SHREWSBURY PUBLIC LIBRARY
609 Main Street
Shrewsbury, MA 01545

PROJECT: TOWN OF SHREWSBURY ACCESSIBILITY PROJECT
SHREWSBURY PUBLIC LIBRARY
DRAWING: FLOOR PLAN
SCALE: 1/16" = 1'-0"
DATE: FEBRUARY 2002

BASEMENT FLOOR PLAN

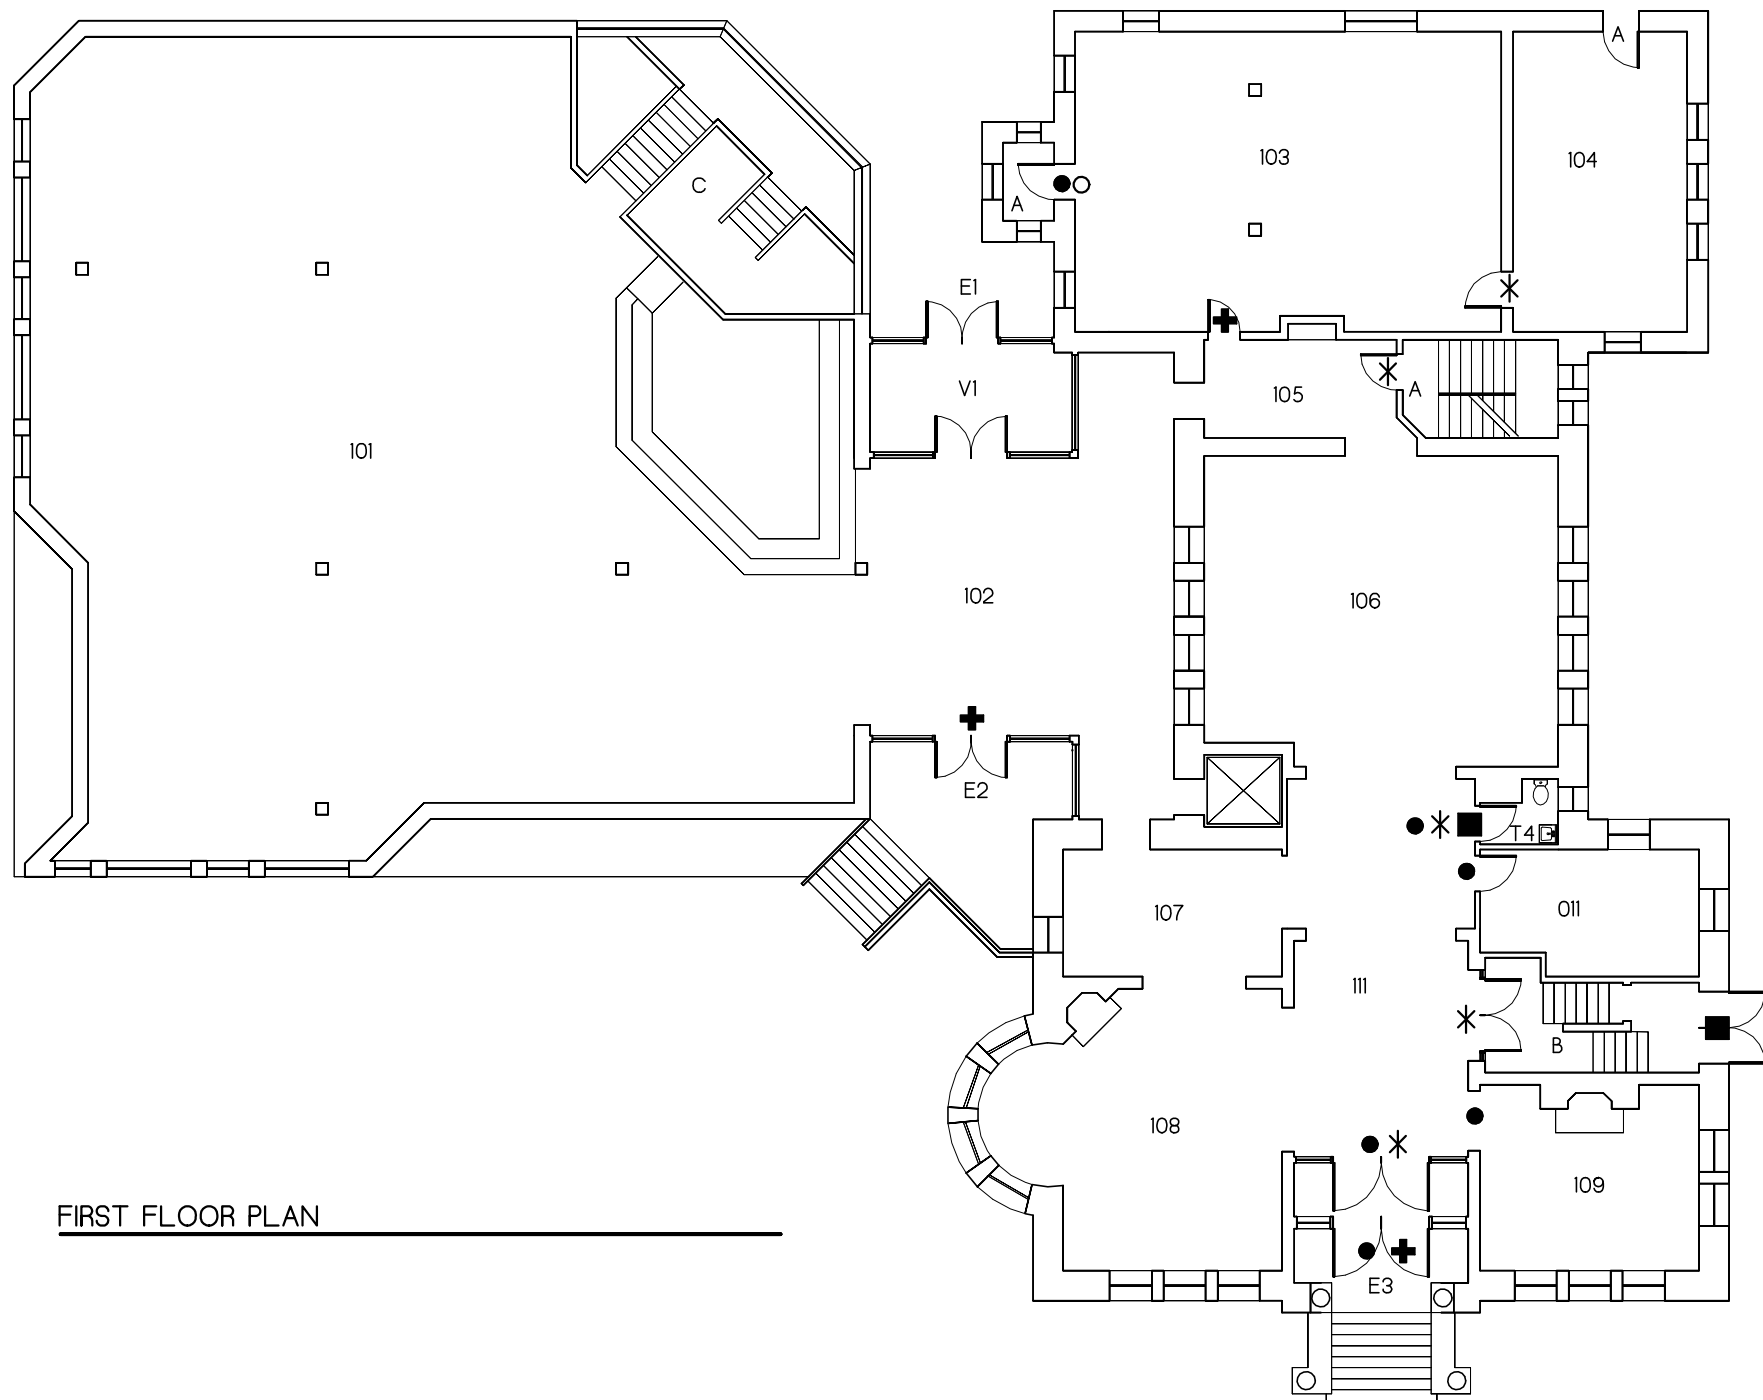
- THE EXISTING DOOR OPENING IS LESS THAN THE REQUIRED 32" CLEAR.
- * THE EXISTING DOOR DOES NOT HAVE THE REQUIRED 18" PULL SIDE CLEARANCE.
- THE EXISTING DOOR DOES NOT HAVE THE REQUIRED 12" PUSH SIDE CLEARANCE.
- EXISTING HARDWARE DOES NOT MEET CURRENT MAAB GUIDELINES.
- ⊕ EXISTING DOOR CLOSER DOES NOT MEET CURRENT MAAB GUIDELINES.

FIRST FLOOR PLAN

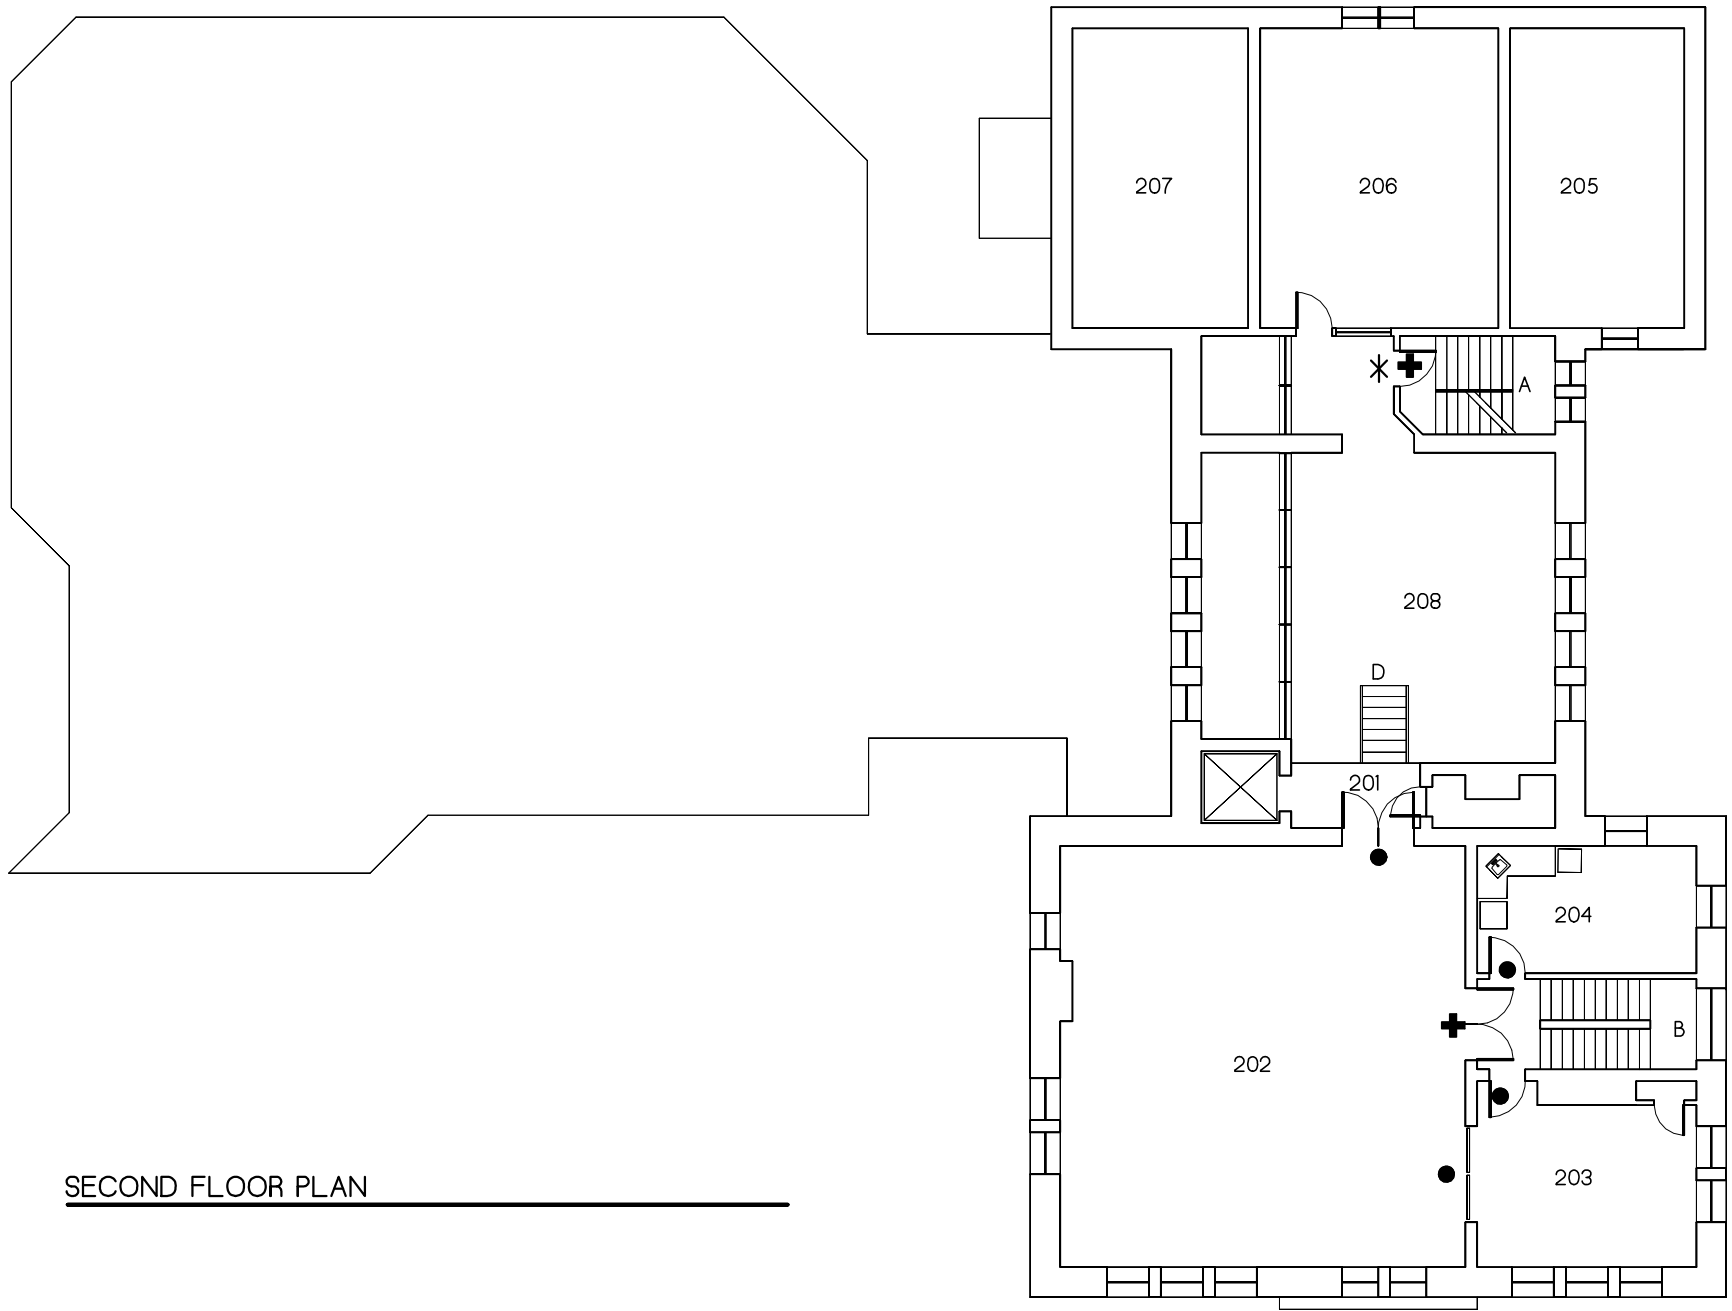
- THE EXISTING DOOR OPENING IS LESS THAN THE REQUIRED 32" CLEAR.
- * THE EXISTING DOOR DOES NOT HAVE THE REQUIRED 18" PULL SIDE CLEARANCE.
- THE EXISTING DOOR DOES NOT HAVE THE REQUIRED 12" PUSH SIDE CLEARANCE.
- EXISTING HARDWARE DOES NOT MEET CURRENT MAAB GUIDELINES.
- ✚ EXISTING DOOR CLOSER DOES NOT MEET CURRENT MAAB GUIDELINES.
